PLANNING AND ZONING COMMUNICATION

AGENDA ITEM: Conduct a Public Hearing to hear public comment, discuss, and take action on a Conditional Use Permit and Site Plan on property zoned General Commercial – Planned Development (GC-PD) on Block 2C, Lot 1R of the Carlisle Addition, Phase C, an approximate 2.0549-acre tract of land situated in the E. P. Holman Survey, Abstract No. 65, Town of Bartonville, Denton County, Texas. The property is generally located at the northeastern corner of FM 407 and Blanco Drive in Bartonville, Texas. The Town of Bartonville file numbers for this application are CUP-2026-002 and SP-2026-001.

CIVIL CONSTRUCTION PLANS FOR LANTANA TOWN CENTER - LOT 1R, BLOCK 2C 2951 FM 407

**PAVING AND DIMENSION
 CONTROL PLAN**
 SHEET NUMBER
C-03

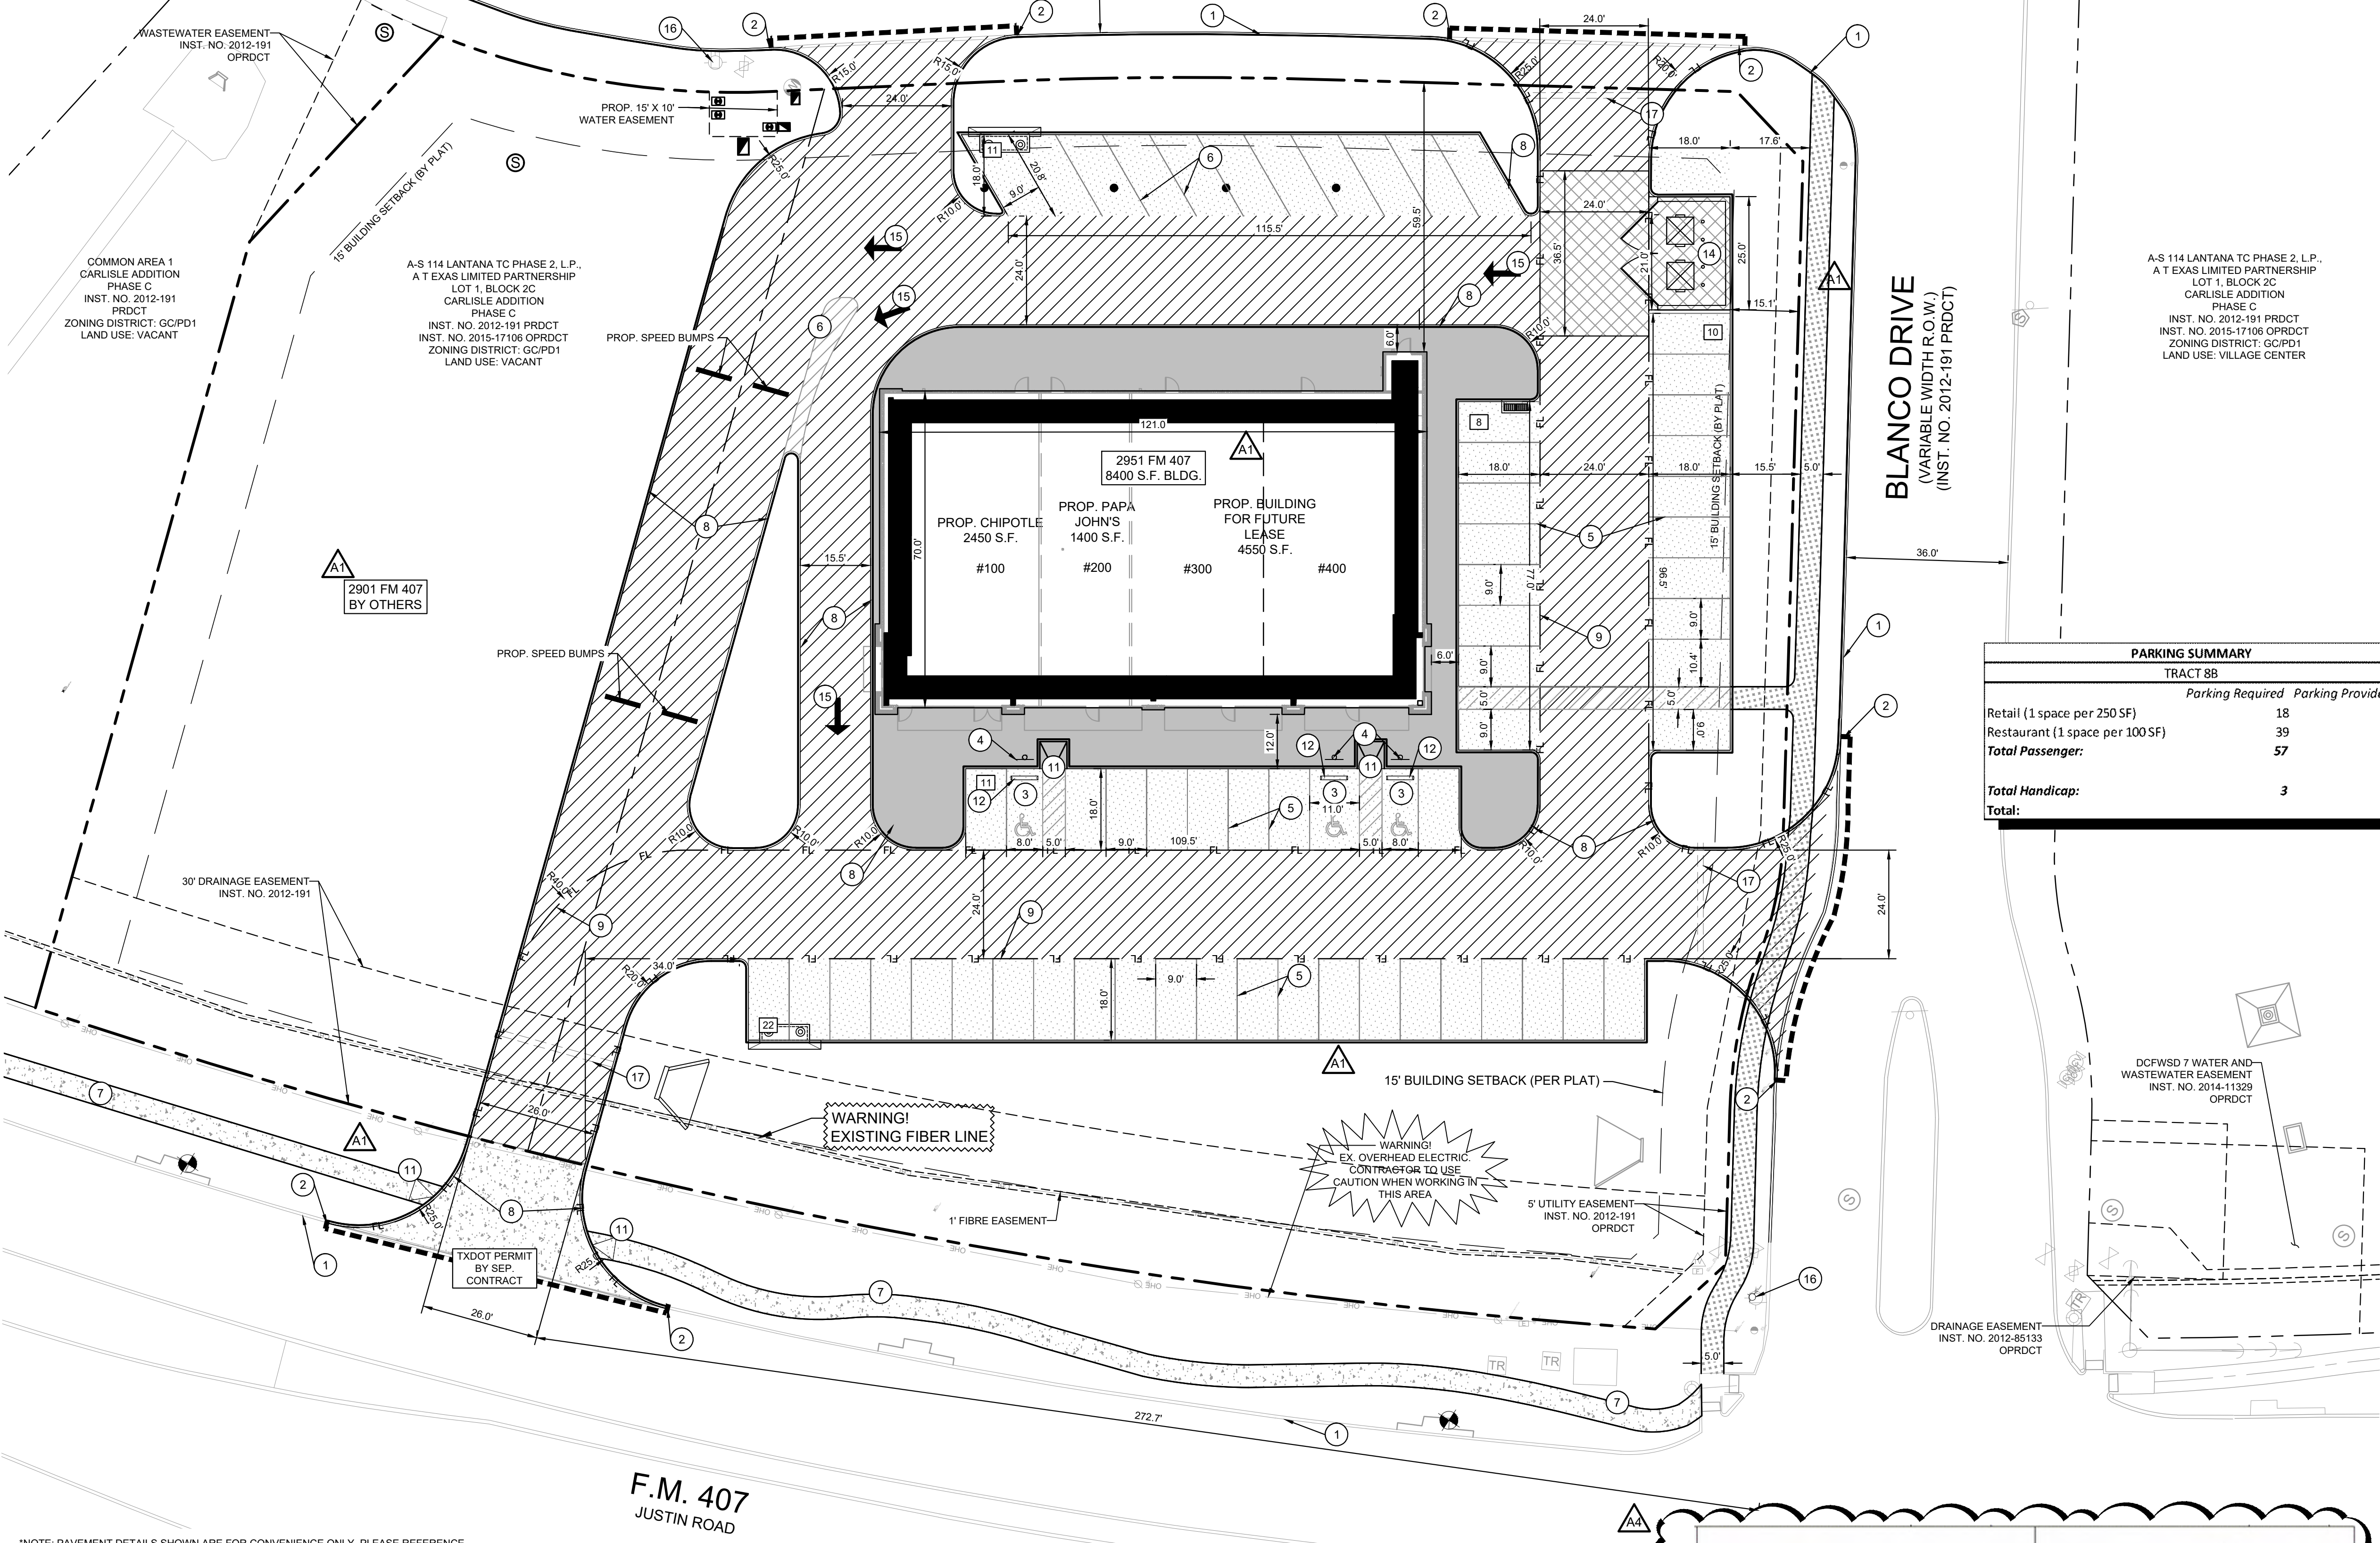
The site provides 62 parking spaces attributed to the proposed use, with three of the spaces being marked for handicapped visitors. Per BZO section 17.6, a minimum of 62 spaces is required; the parking table in the site plan package included an error in the parking standards resulting in an incorrect parking

4. All fire lane turn radii shall be a minimum of 20 feet. This shall be reflected on a revised site plan to reviewed and approved by Town staff prior to issuance of a building permit.

5. The driveway from the site onto FM 407 shall be a right-in/right-out, with a raised porkchop directing ingress and egress. This shall be reflected on a revised site plan to reviewed and approved by Town staff prior to issuance of a building permit.

PROPOSED SCREEN FENCE SECTION
N.T.S.

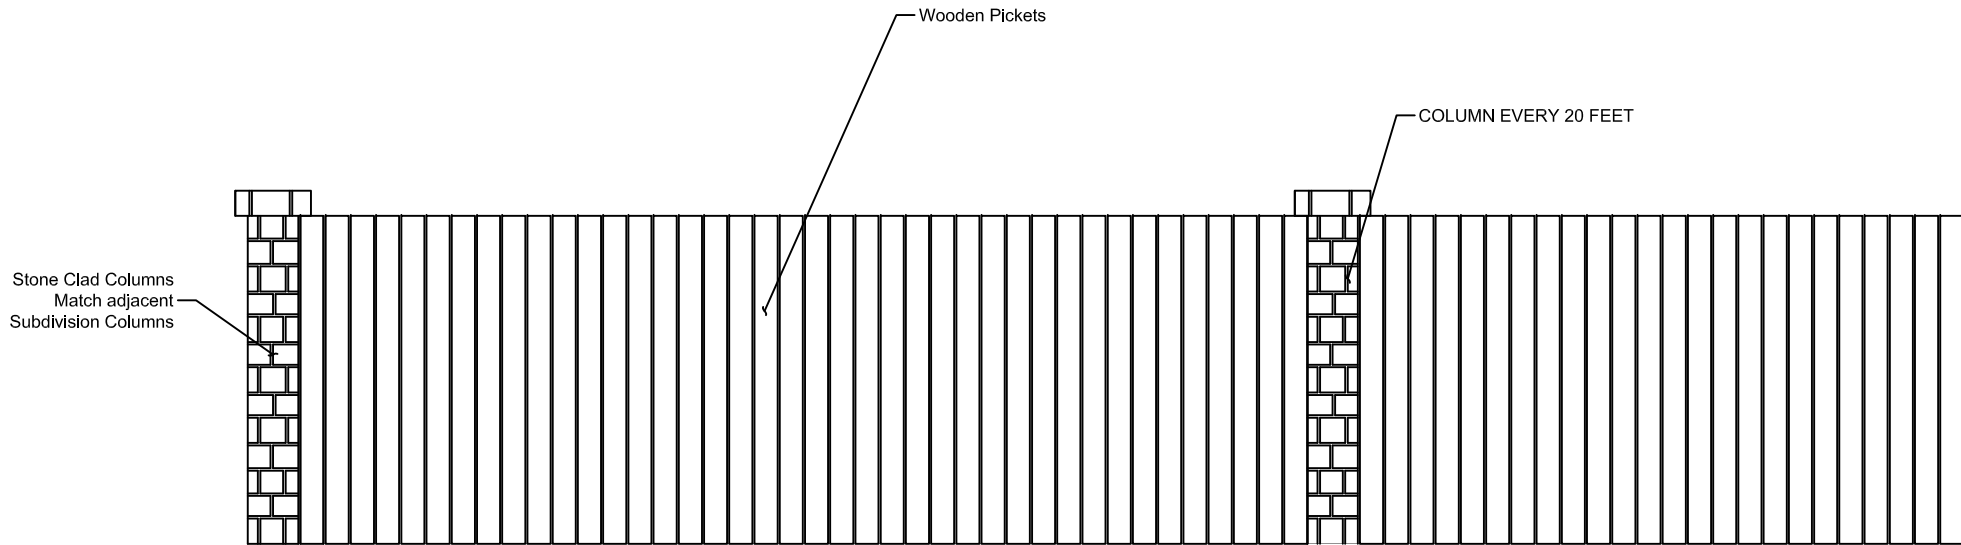
The applicant provided a screening fence detail for the northern parcel boundary, which abuts an open space tract in the vicinity of single-family homes in the Lantana neighborhood. While the applicant indicates that this screening fence will be installed with the adjacent future development, staff recommend that this fence be installed in accordance with the design requirements in Bartonville Zoning Ordinance Section 13.3.C.14. and with the current proposed development to mitigate impacts to neighboring residential uses. With these findings and proposed conditions listed below, criteria 3 through 7 are met.

1. The proposed screening fence on the north side of the property shall be installed prior to issuance of a certificate of occupancy for the proposed building, and shall meet all design requirements found in Bartonville Zoning Ordinance Section 13.3.C.14. A revised screening wall detail shall be reflected on a revised site plan to reviewed and approved by Town staff prior to issuance of a building permit.
